Project: 08-25-3320 HCA LSMC DIETARY EXPANSION
2100 SE BLUE PARKWAY
LEE'S SUMMIT, Missouri 64063

RFI #034: DietEx - Life Safety Dampers

#002 Life Safety Dampers

M02-01

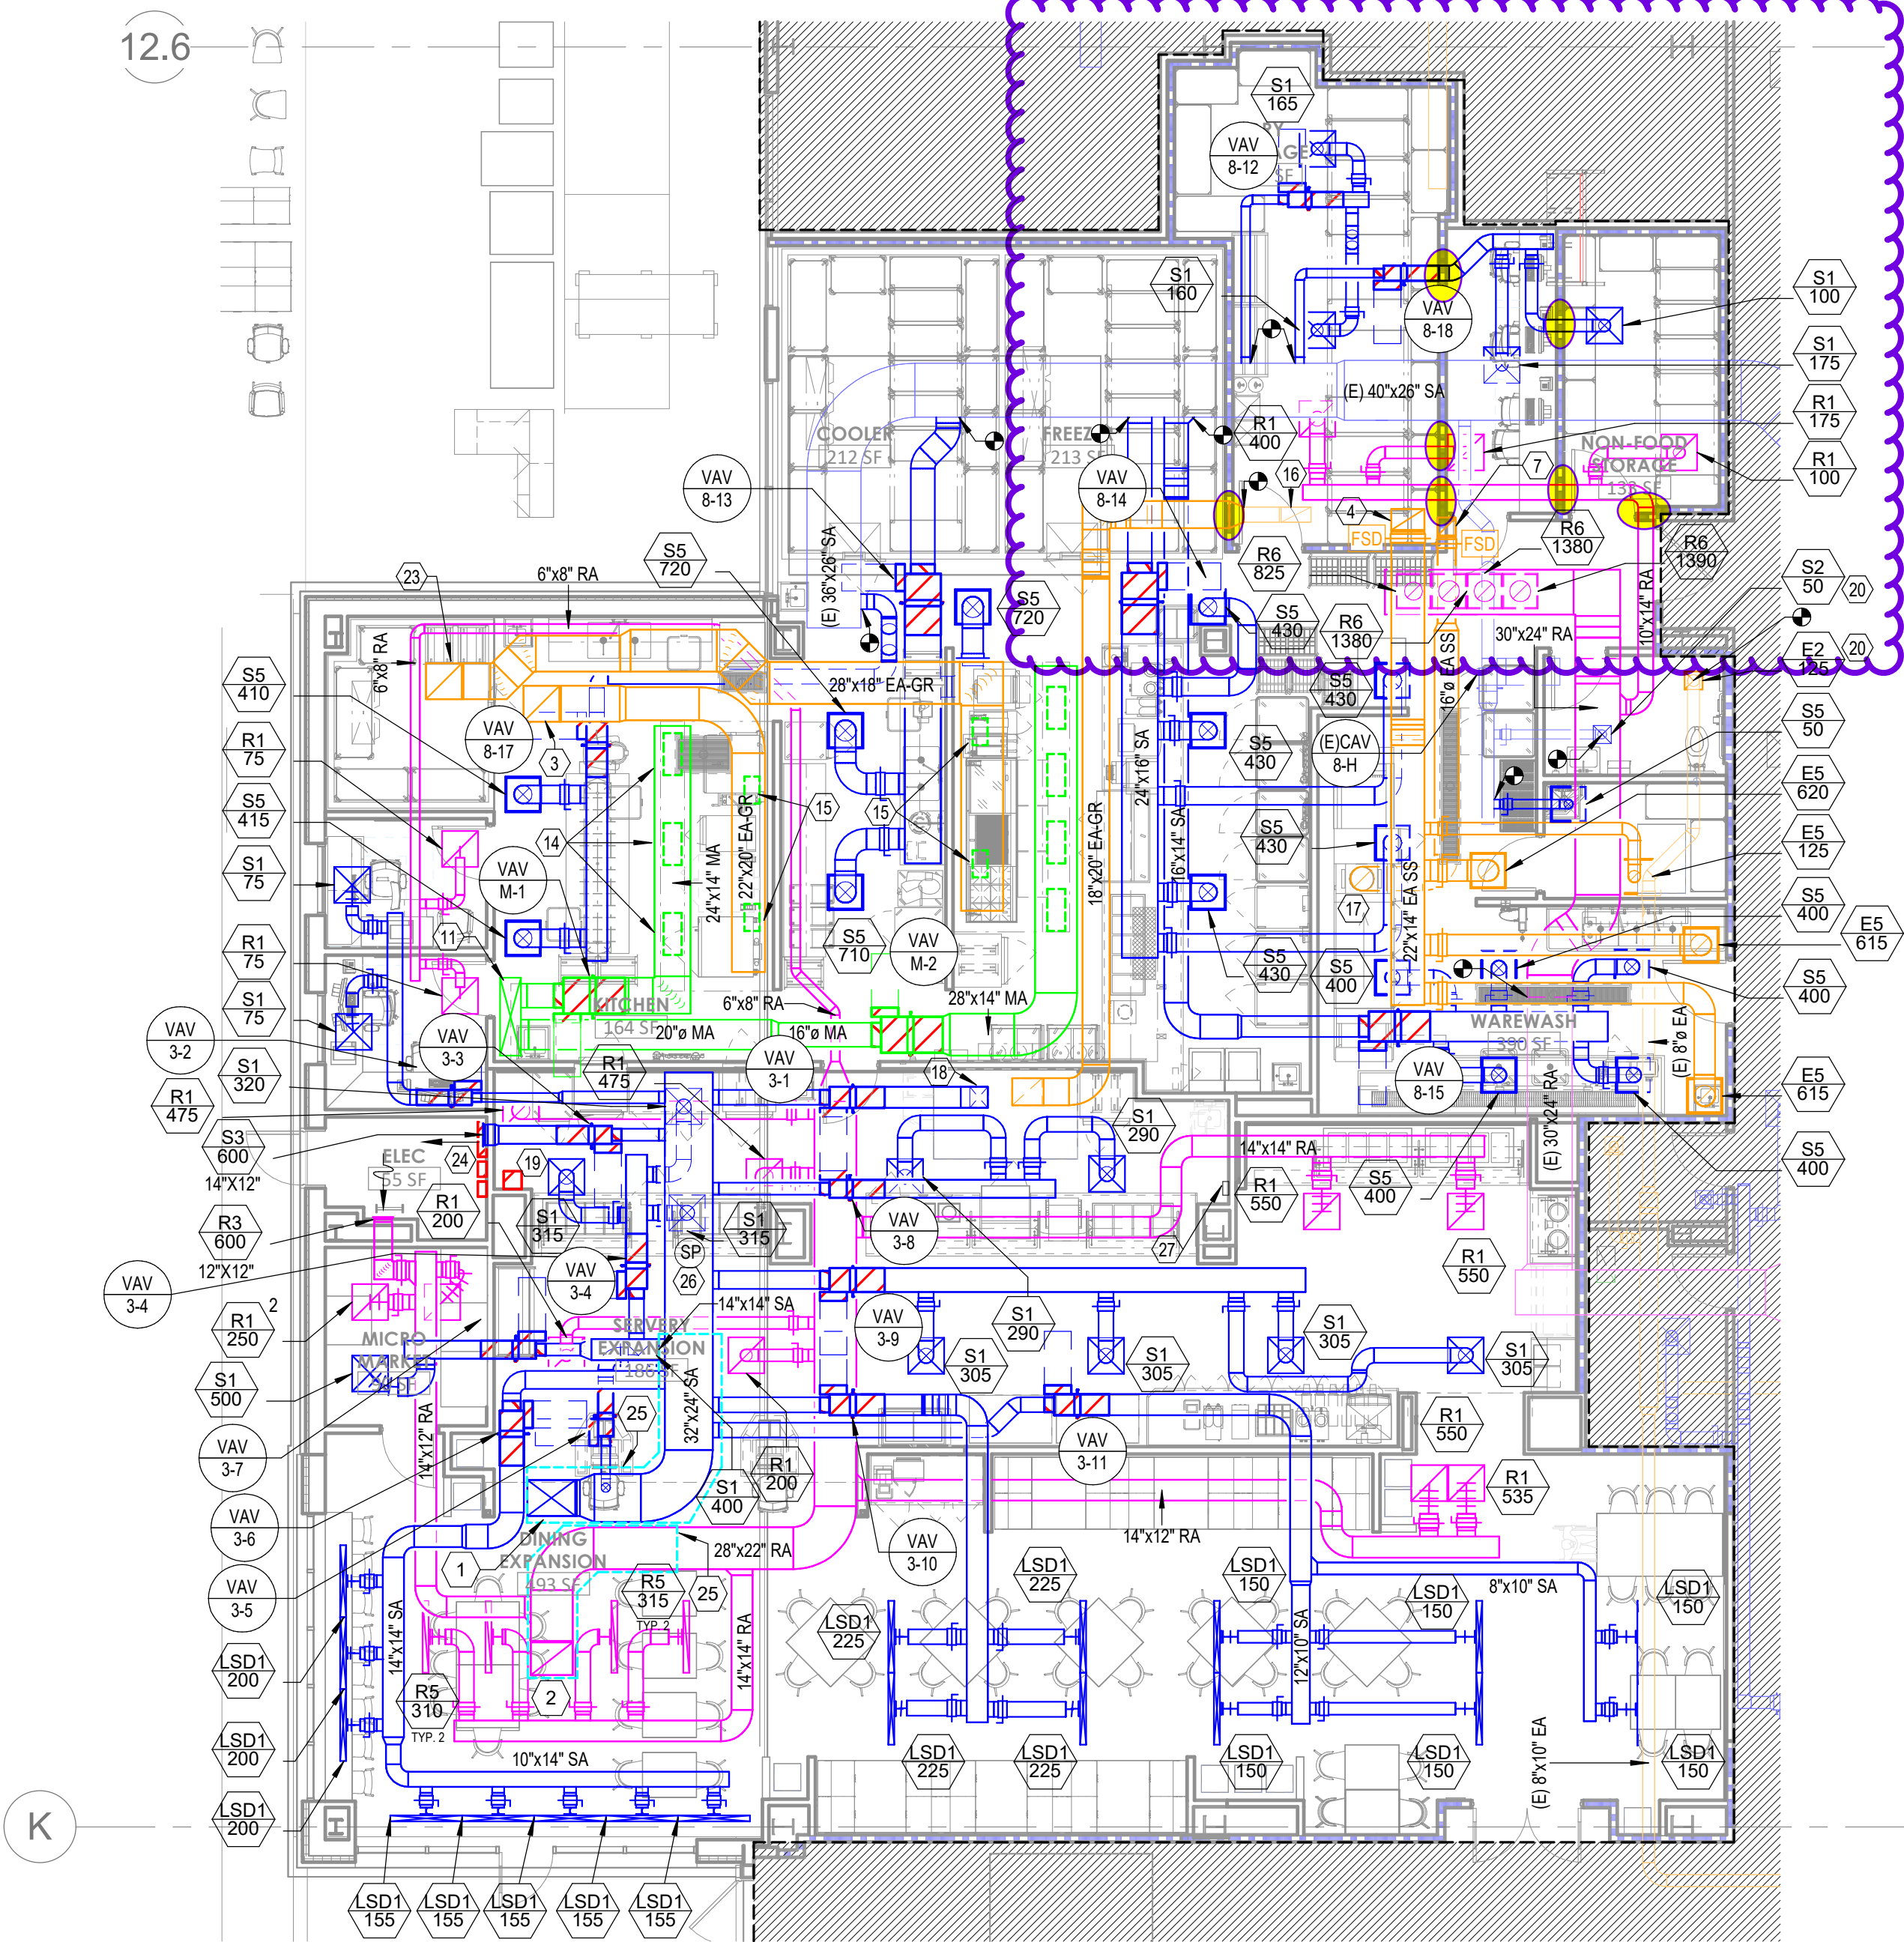
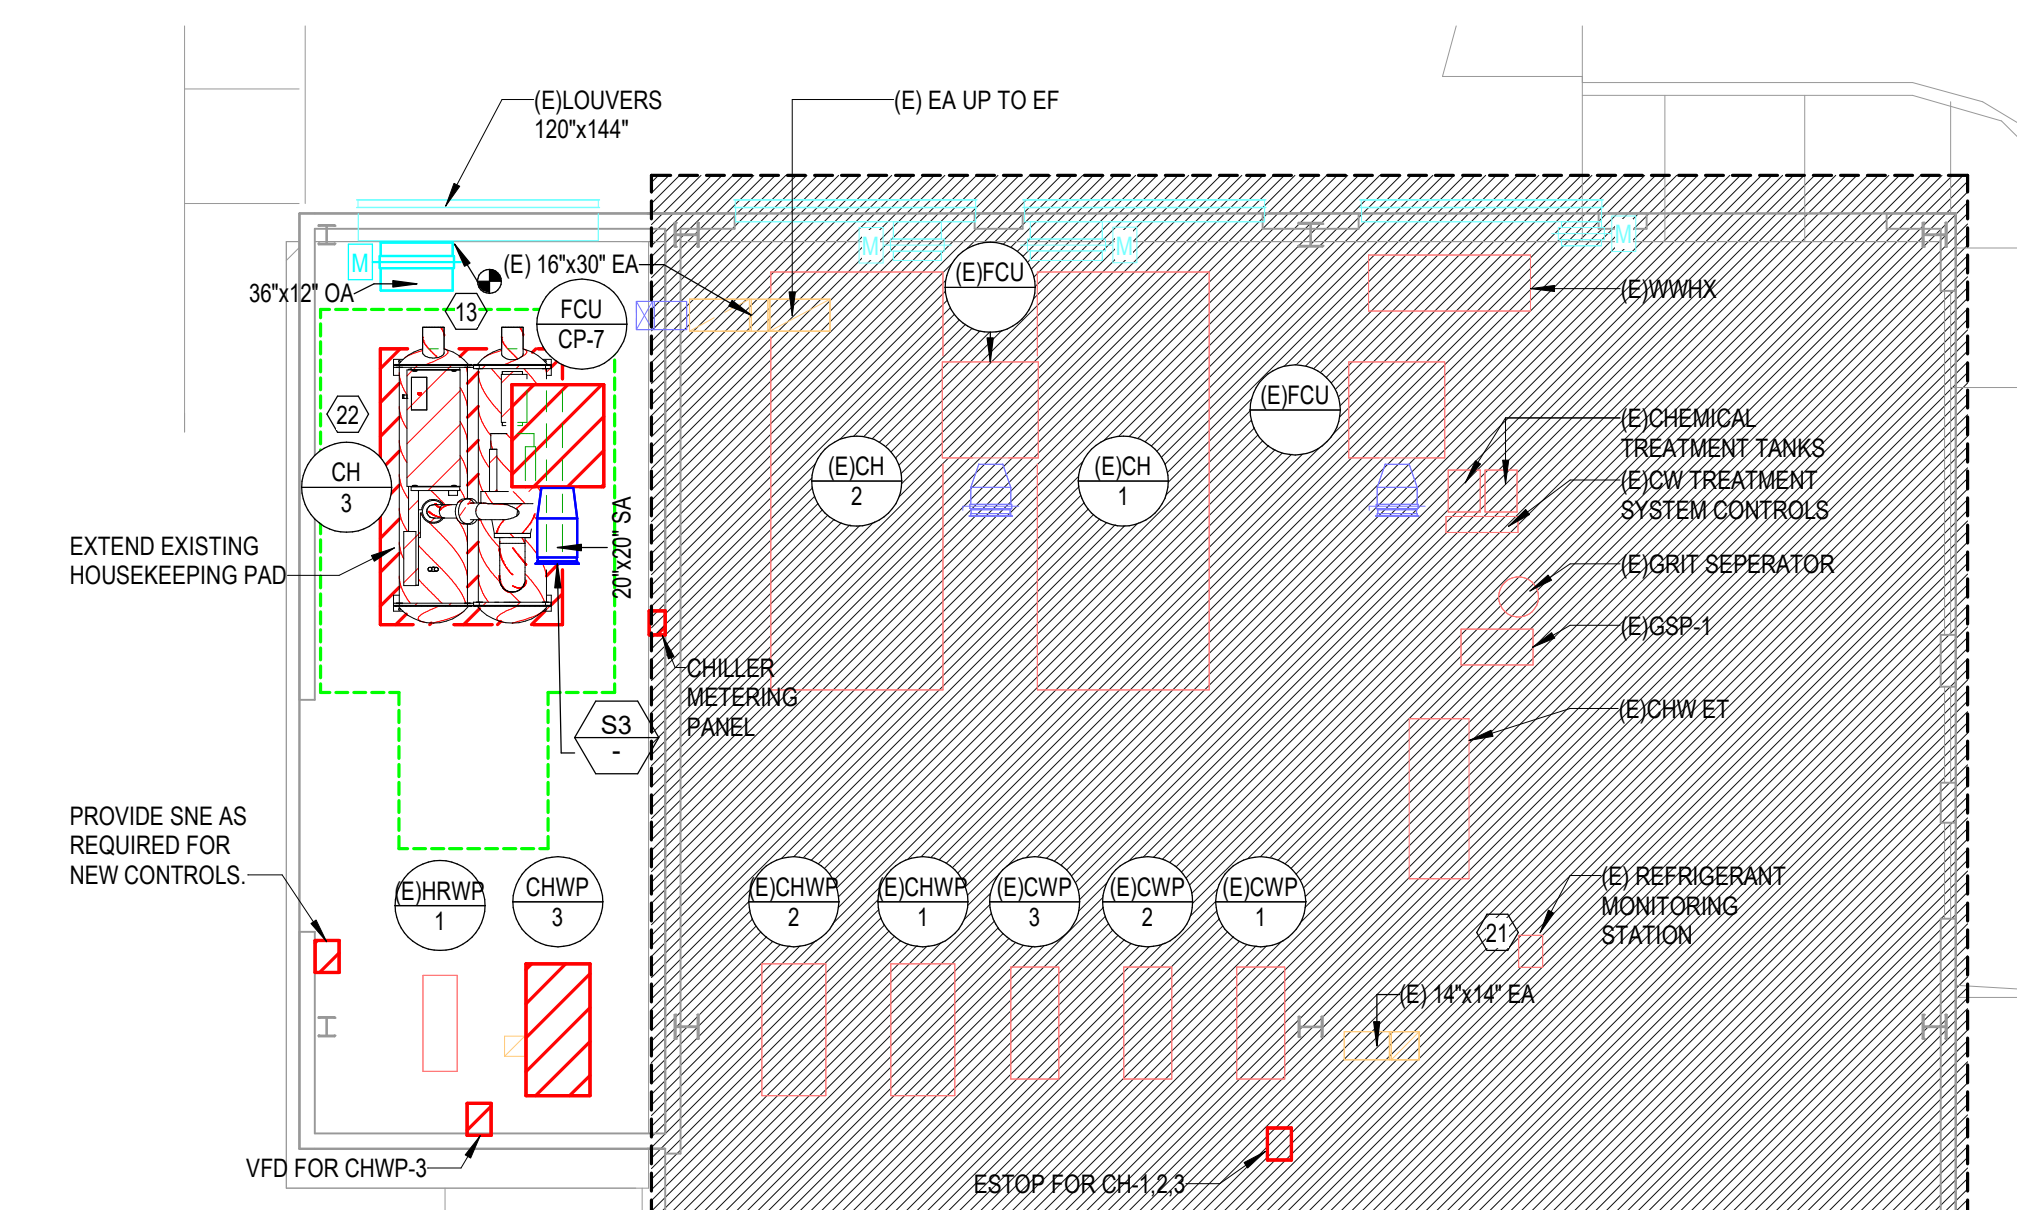
During the BIM coordination meeting on 09.03.25, the question was asked to the EOR if the areas noted in the cloud on the attached drawing required life safety dampers. - P1

Please advise if life safety dampers are needed where ducts pass through fire rated walls in Dietary Expansion. - Nab-LA

Reference yellow ovals for areas in question. - Nab-LA-09.04.2025

Life safety dampers are not required where ducts pass through 1-hour fire-rated walls in the Dietary Expansion area. Fire dampers are only required at penetrations of walls or assemblies with a fire-resistance rating greater than 1 hour or where otherwise

indicated on the contract documents. Sheet AC 101 shows that the walls in question are 1 hour rated fire barriers.
